## ADDENDUM NO. 1

**Addendum Publish Date:** November 17, 2022  
**Bid Questions Due Date:** November 15, 2022, 3:00pm EST  
**Bid Due Date:** November 22, 2022, 3:00pm EST  
**Bid Name:** FOREST PARK IMPROVEMENTS  
**Bid Number:** WSPP-230023-GD

**FOREST PARK**  
**GAINESVILLE, FL**  
**ALL FIELDS AND PROPERTY LINES**  
**NEW SITE PLAN, CHANGE TO B POLES**  
**FIELDS @ 30 FC, COURTS @ 40 FC**

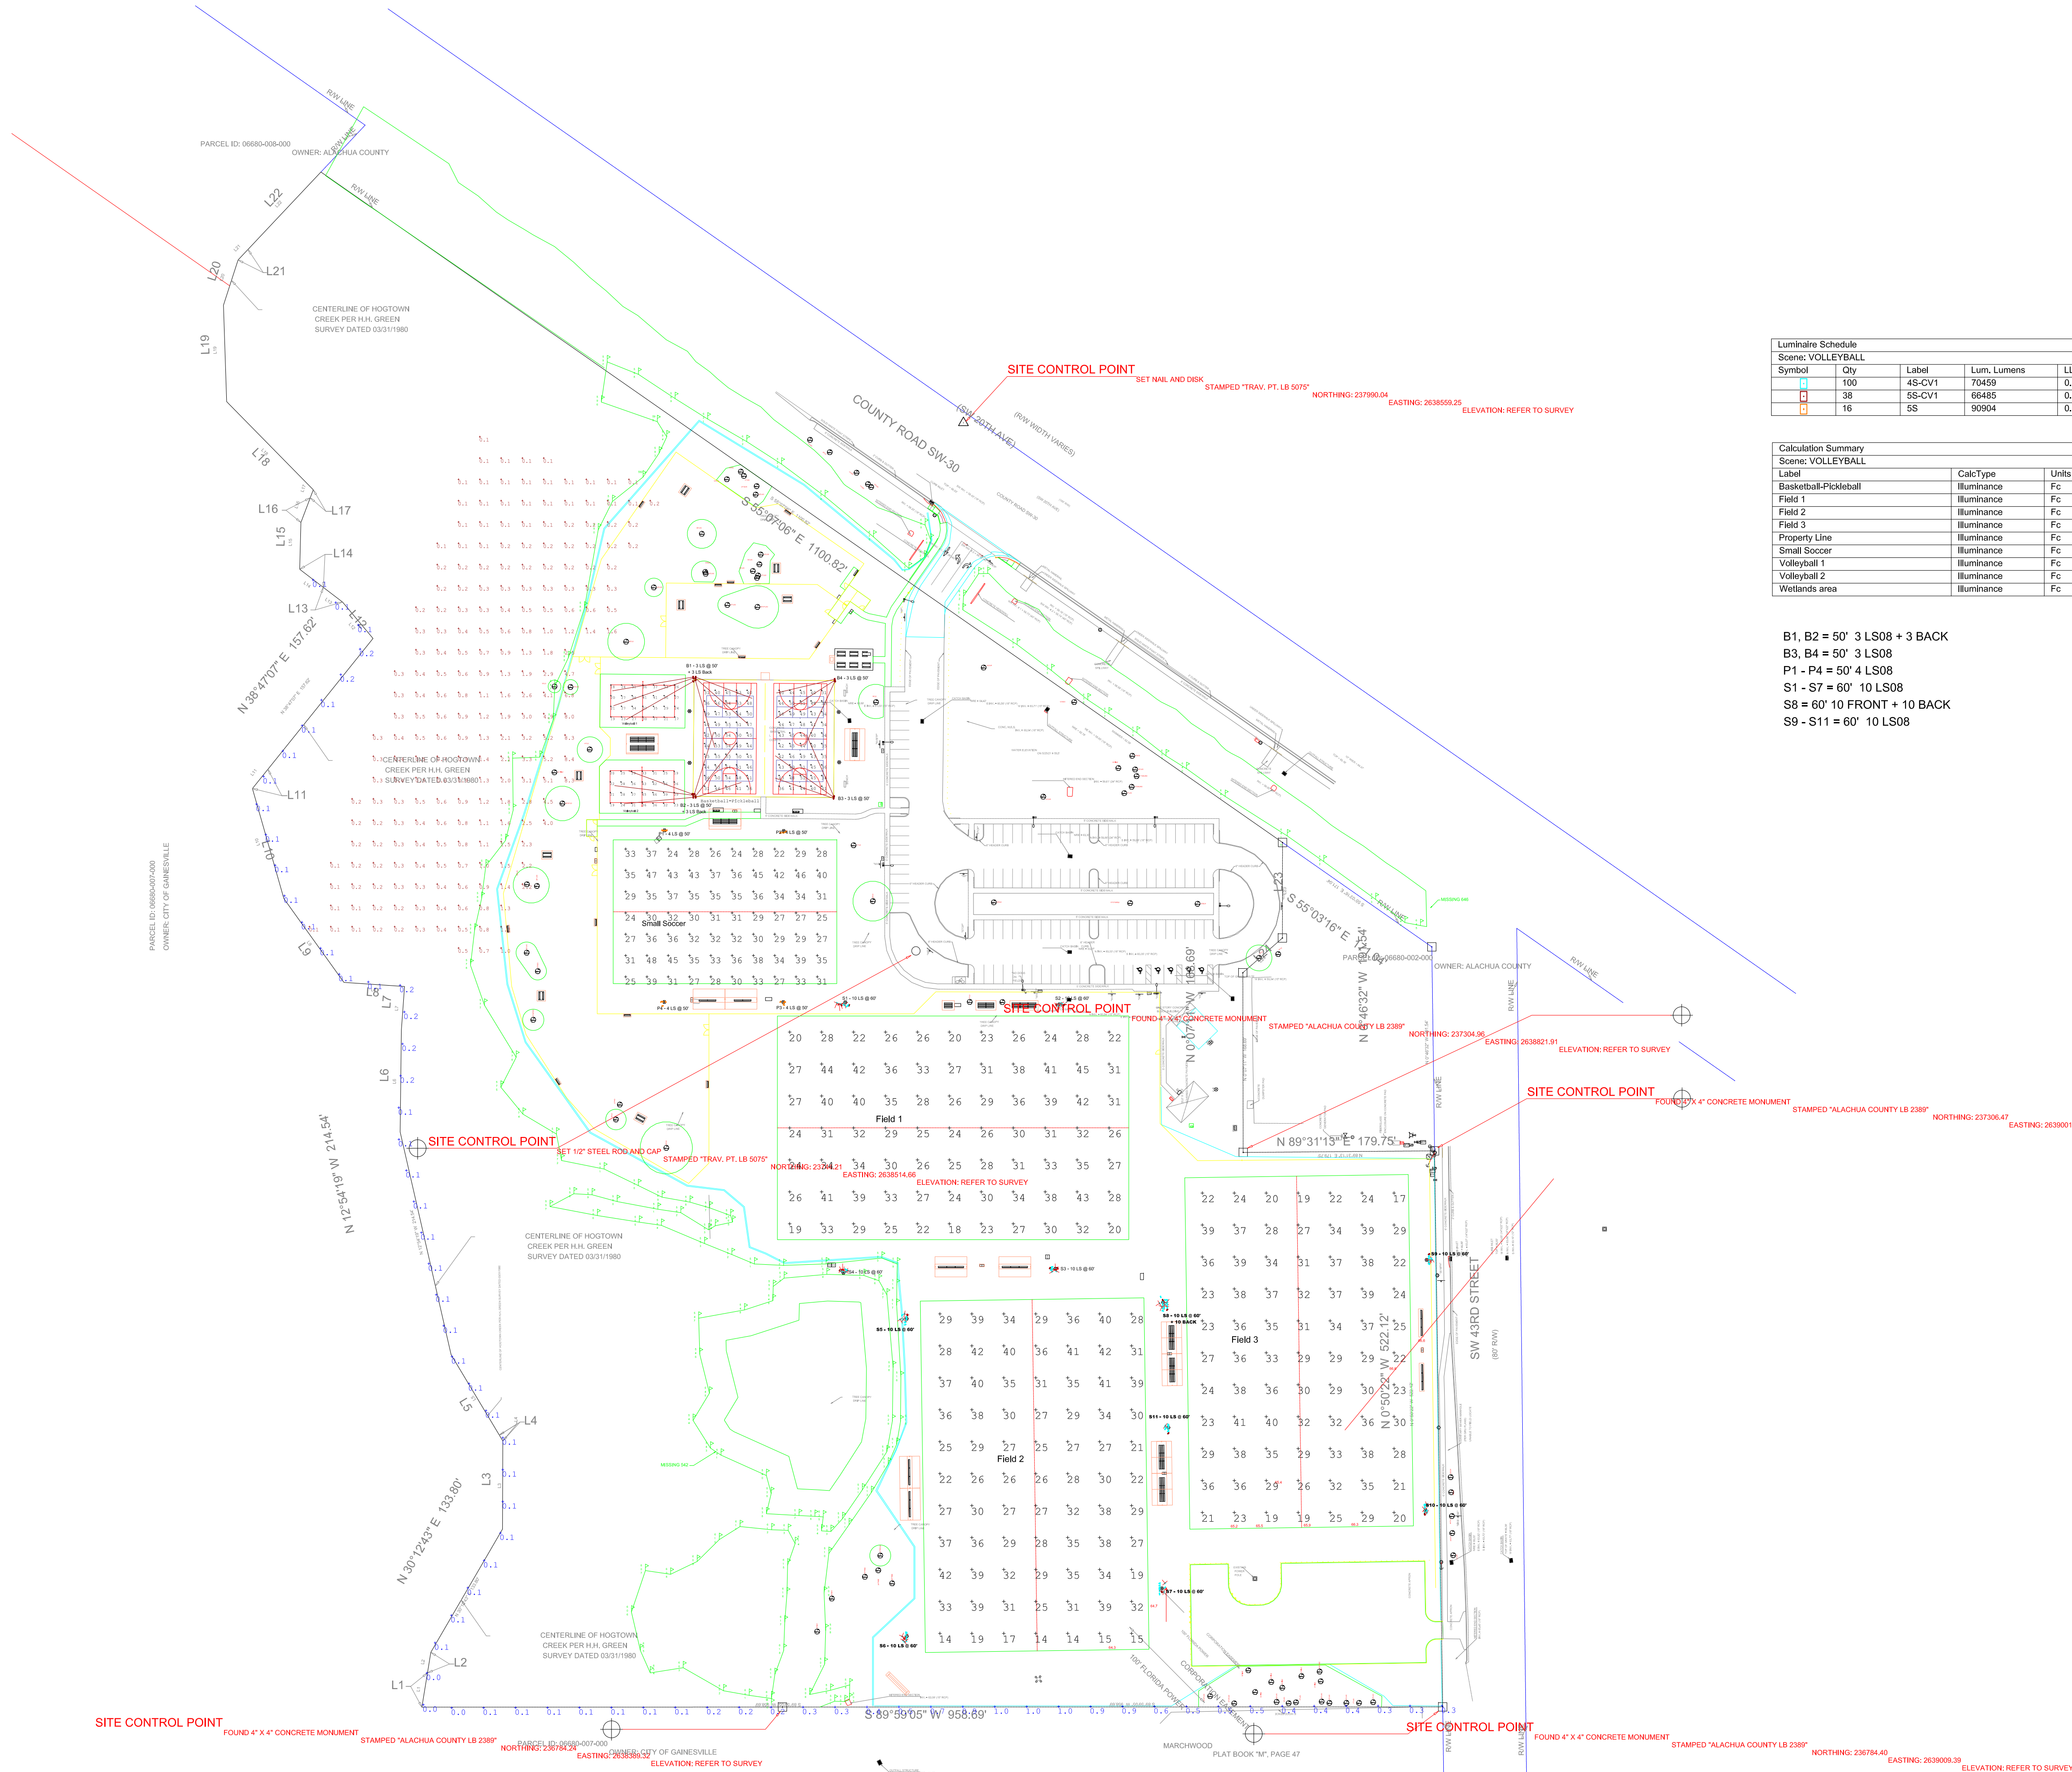
Please incorporate the attached photometric plan and six power sheets (P-1, P-2, P-3, P-4, P-5, and P-6) dated 11-16-22 into the bid set of drawings. There has been a substantial redesign of the electrical system to accommodate the increased lighting requirements. The system was converted to 480V.
